2019 Farley NRC Written Exam

QUESTION #2

To: Michael Meeks, Senior Operations Engineer
From: Reed, Brian
CC: Recipient names
Date: 7/17/2019
Re: NRC Written Exam Question Student Challenges

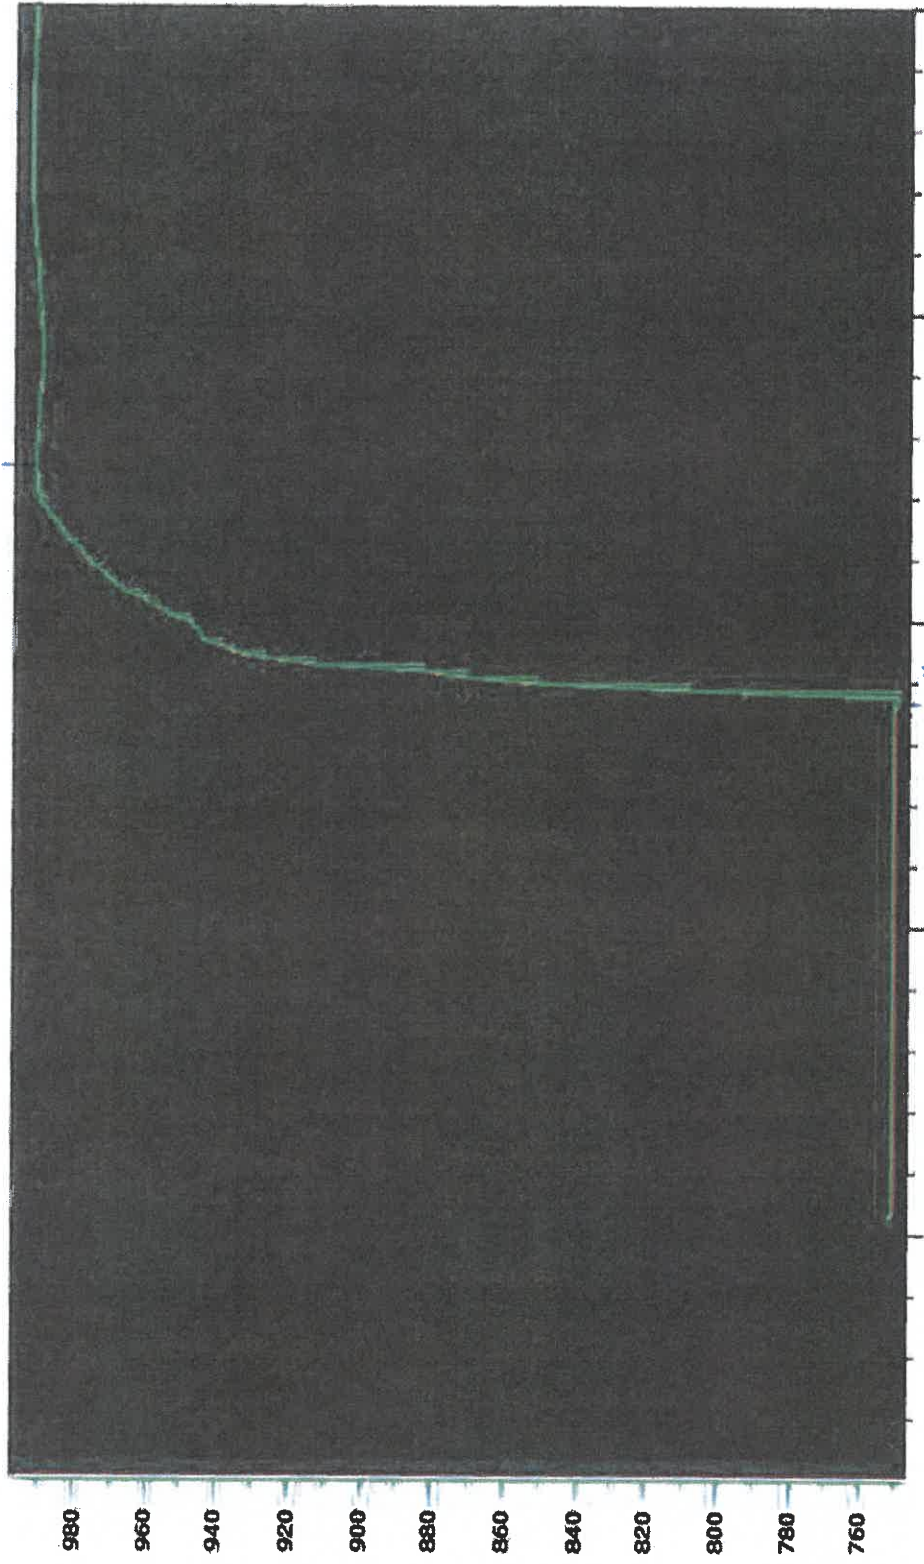
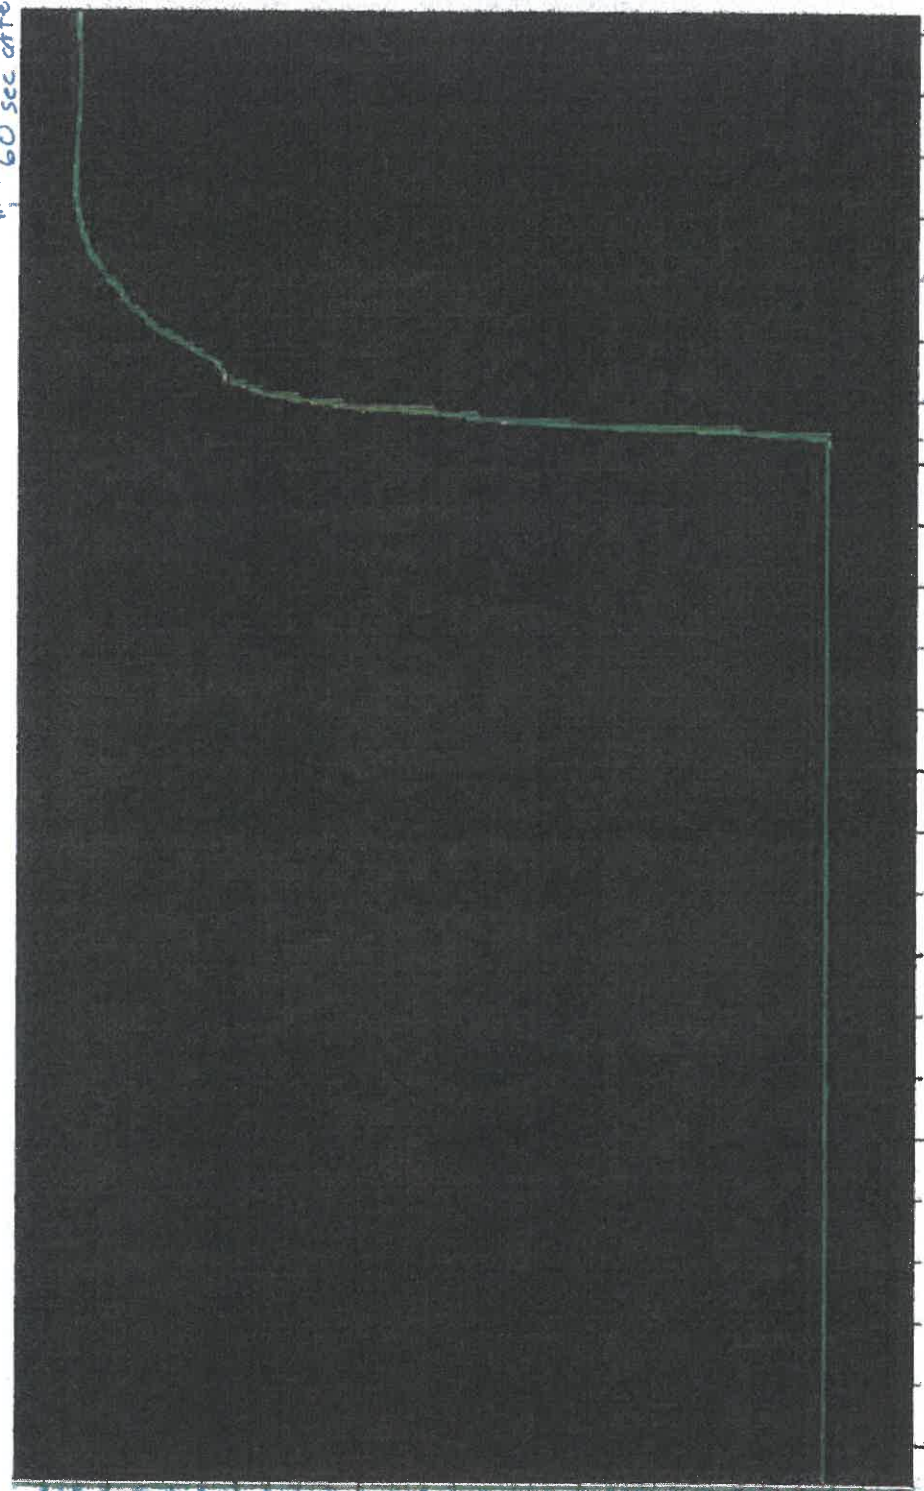
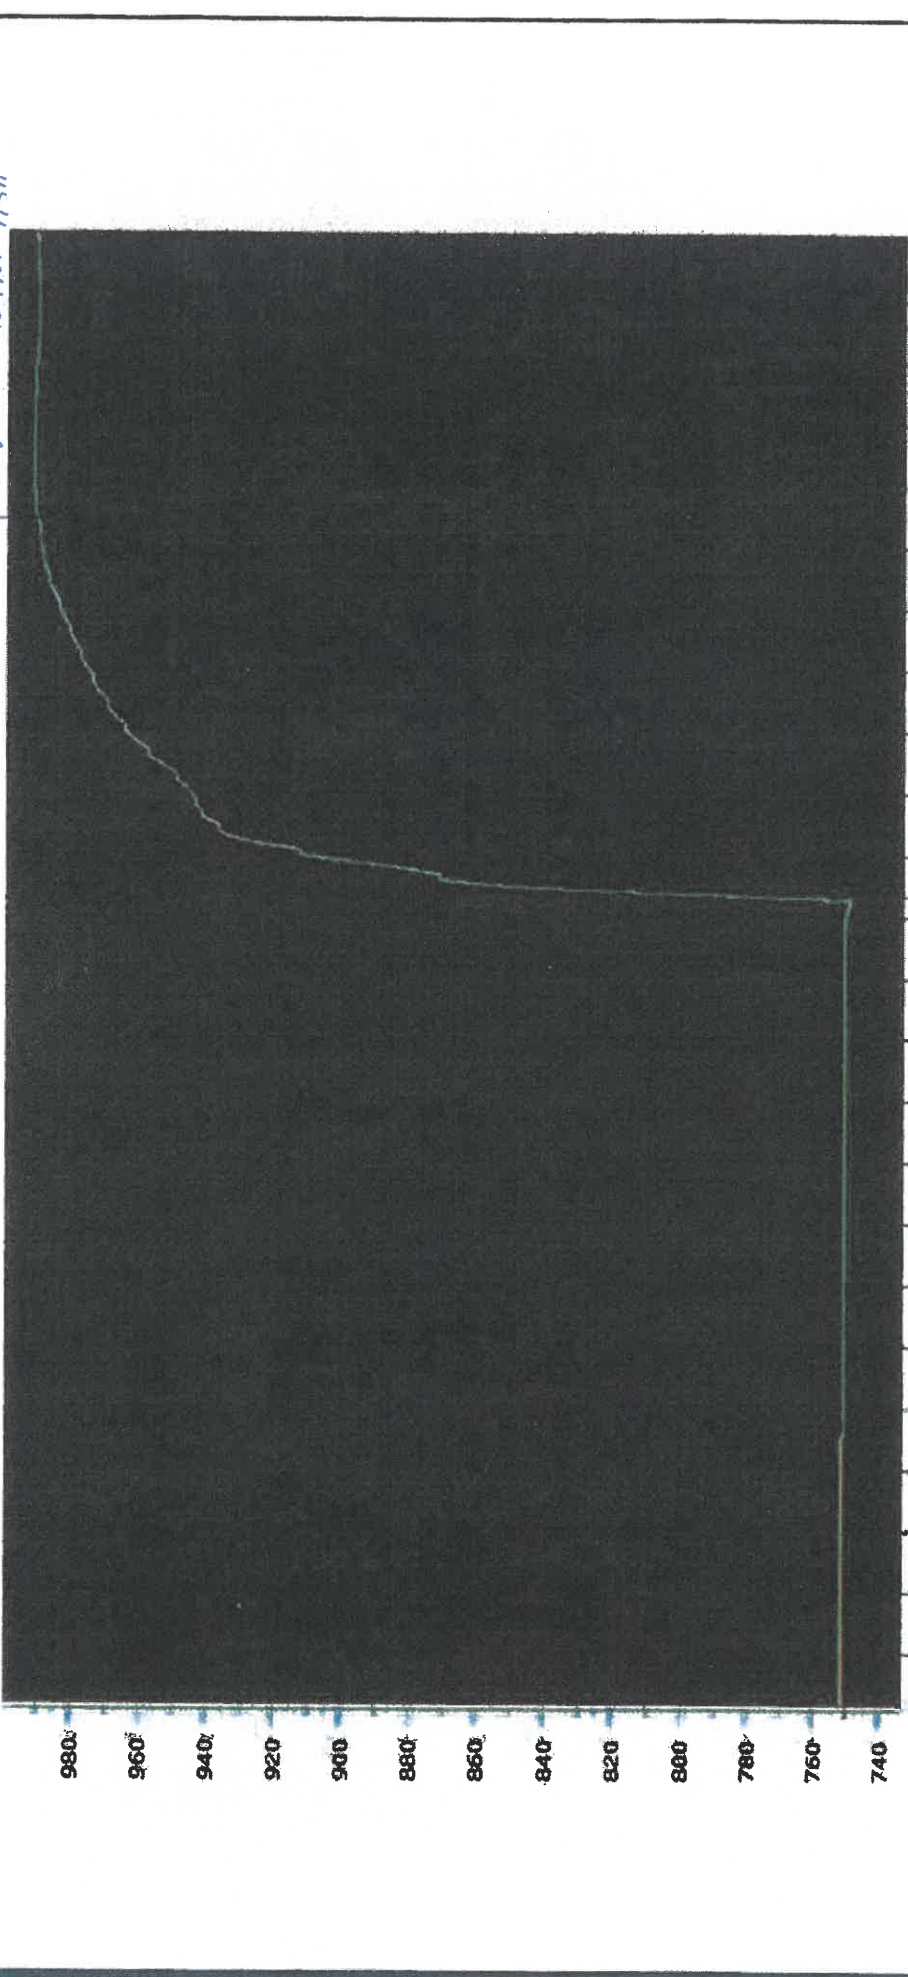
Recommendations: Recommend deleting this question from the exam due to no correct answer being provided. As ran on the plant referenced simulator, steam generator pressures rise rapidly for approximately 40 seconds after the initiating event followed by stabilization at approximately 55 seconds and beyond.

2. Simulator Integrated Plant Computer (IPC) trends were analyzed after the loss of an RCP. Based on the trends (attached) Steam generator pressures rise rapidly for approximately 40 seconds after the initiating event followed by stabilization at approximately 55 seconds and beyond with steam dumps operating to maintain pressure.

3. See attached IPC trends from the Plant Reference Simulator for BOL, MOL, EOL conditions. IPC trends represent a trip of the C RCP, and values for B/C SG pressures as provided in the stem.

4. Looking at the specificity of the time stated in the question and the trends from the IPC, the correct answer is - stable for both SGs. The correct answer was not provided on the exam.

1. Question 2- The facility agrees with the student's recommendation to remove question 2 from the exam due to no correct answer available. The question asks what is happening to the SG Pressure 60 Seconds after the transient. While the pressure was greater at one minute than at the start, the pressure at 60 seconds has stabilized. There is no choice for a stable pressure therefore there is no correct answer.
